**STAFF REPORT**

**CASE NUMBER:** P.D. 10-309

**DEVELOPMENT NAME:** Union Avenue and Cooper Street Planned Development

**REQUEST:** A planned development to permit retail use (CVS Pharmacy)

### PROPOSED BUILDING ELEVATIONS

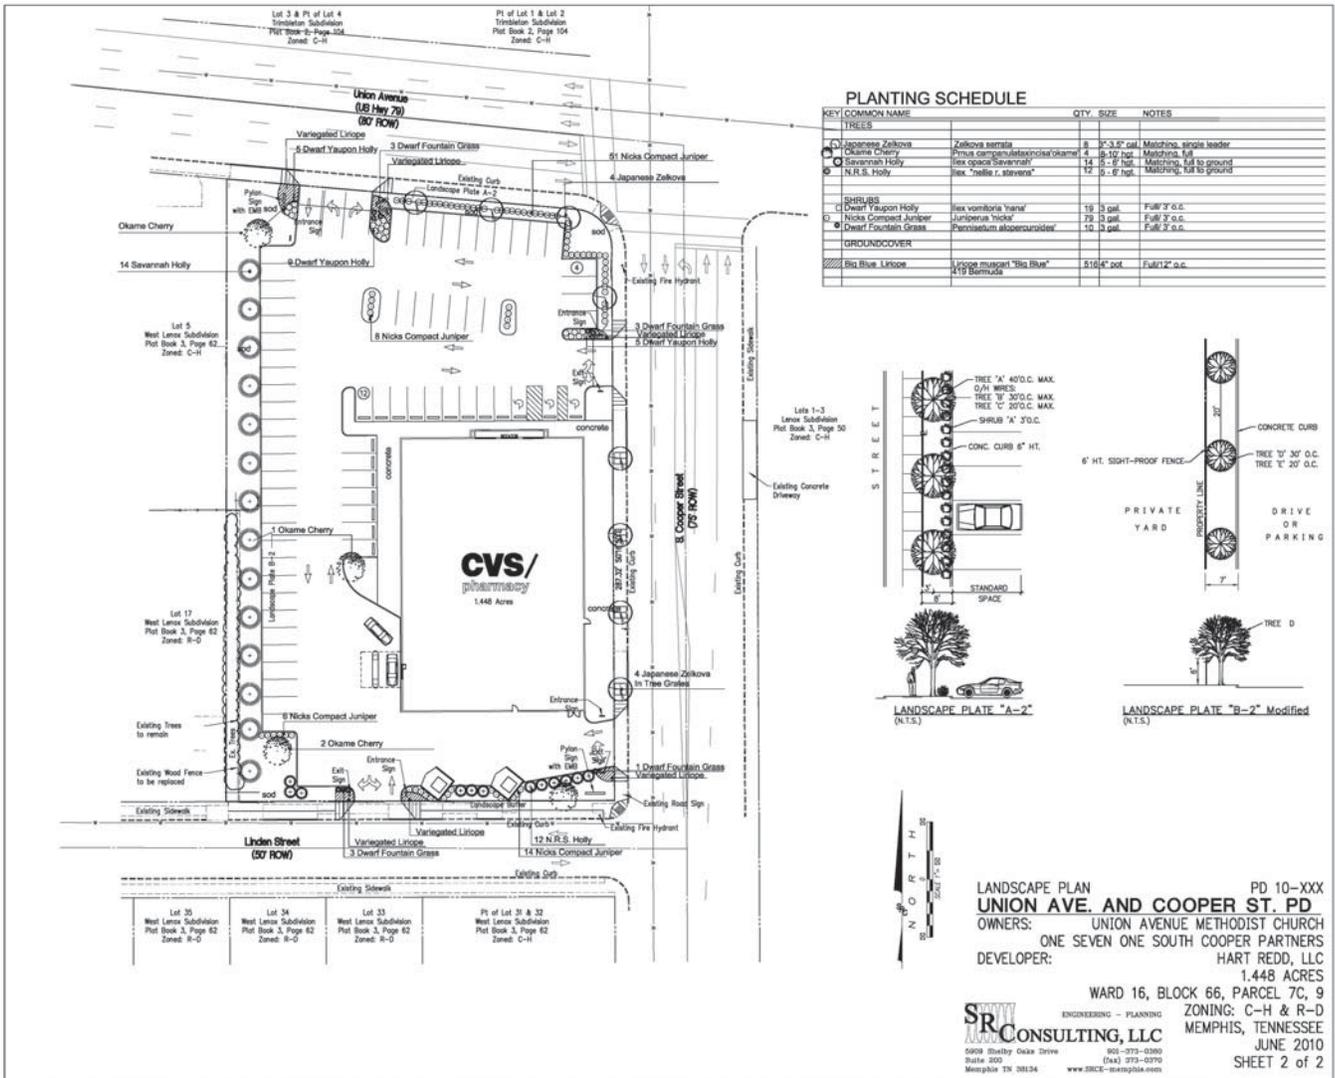
2. The 24' wide two way drive aisles are bare minimum; this is not very customer-friendly.
3. The building is just plain unimaginative with its two colors of concrete masonry units and its plain boxy look. The lack of glass area and the ability to see into the store and thus some activity is just not neighborhood friendly.

4. The Linden Street elevation which will be prominent to north bound traffic on Cooper looks like it belongs to a different building and certainly must be corrected.

5. From the elevations presented there appears to be no attempt to conceal the roof top equipment that will obviously be employed.
6. The landscape plan is equally unimaginative in that there are no trees within the parking area, just continuous rows of parking spaces. For example there should be a landscape island between every 5 or 6 spaces, and the islands should contain a tree and other plant material as well.(see Office Depot lot on Union Ave. near Forrest Park for a good example, with crepe myrtles in islands between parking spaces)
